**2020-03-23**

**Table 2. Safety Recall Code [0167] Kit (Part No. 91500085) Contents**

**Figure 1. Vent Baffle**

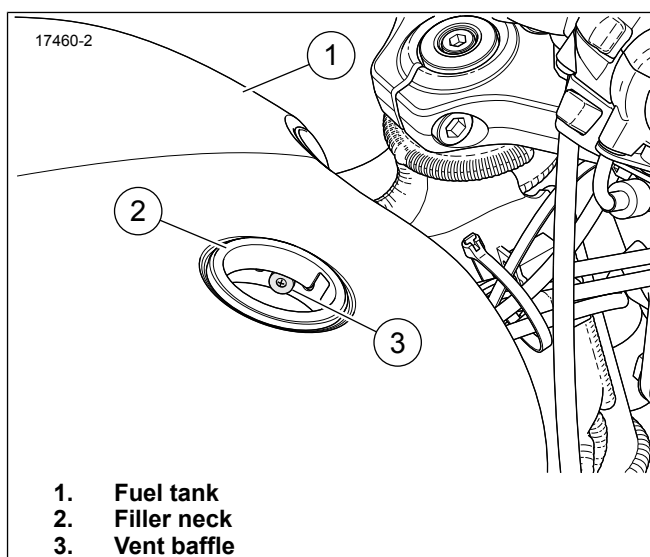
4. See Figure 1. Remove the vent baffle (3) from the filler neck (2).
5. Install the **new** vent baffle.
6. Install the fuel tank cap.

**Figure 2. Fuel Pump - 61200001A**

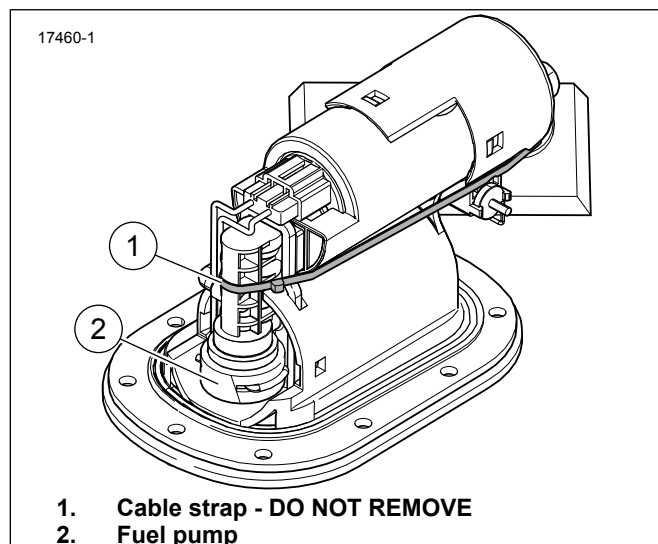
- See Figure 2. **61200001A**: This fuel pump is designed with a cable strap (1) installed on the pump, do not remove.

**Figure 3. Fuel Pump - 61200001B**

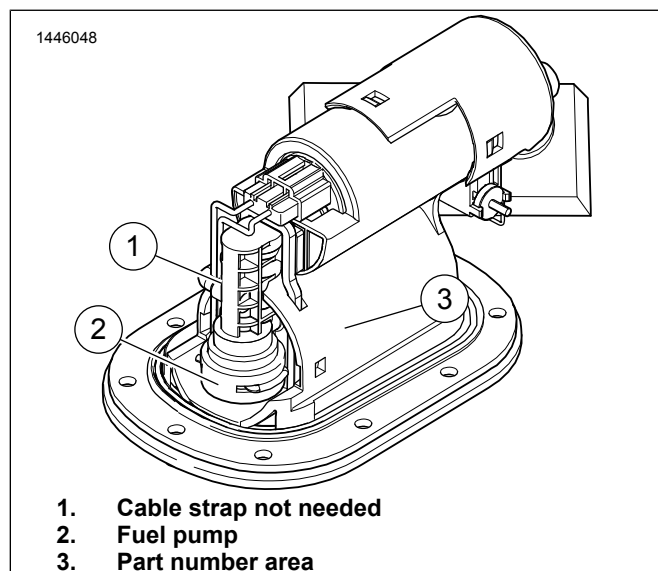
- See Figure 3. **61200001B**: This fuel pump is designed without a cable strap (1) installed on the pump, cable strap is not need. The part number is etched (3) on updated fuel pump.
